Technical Service Bulletin

Topic	Replacing front wishbone links
Market area	Bentley: worldwide (2WBE),Hongkong-Macau (5HK)
Brand	Bentley
Transaction No.	2043974/2
Level	EH
Status	Released for publishing
Release date	Jun 16, 2016

Front wishbone link requires replacement (lower lever).

Figure 3

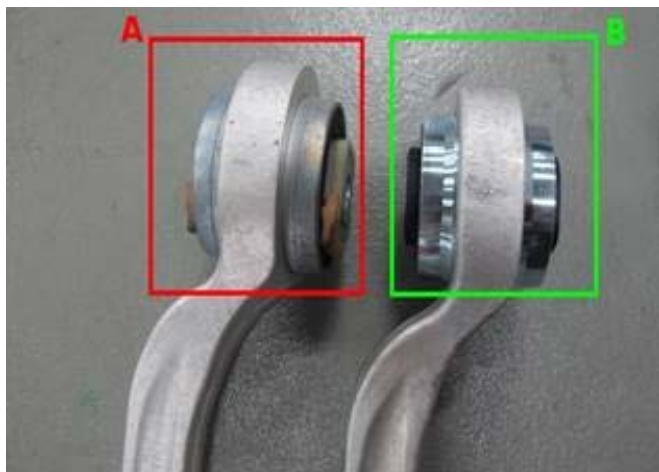
Only 'new' specification front rearward lower levers are available (containing U3 bush)

- Figure 3, shows the difference from the opposing side
- A is the original U1 bush equipped lower lever (non tapered)
- B is the new specification U3 equipped lower lever (with tapered ends)

If it is necessary to fit a replacement lower lever then ensure on completion that these levers have the same bush type do not fit U1 and U3 equipped lower levers on the same vehicle

A vehicle fitted with original lower levers containing U1 bush will require both the left and right hand side lower levers to be replaced.

If the vehicle is currently fitted with the new specification lower levers containing the U3 bush then a single lower lever can be replaced when technically appropriate
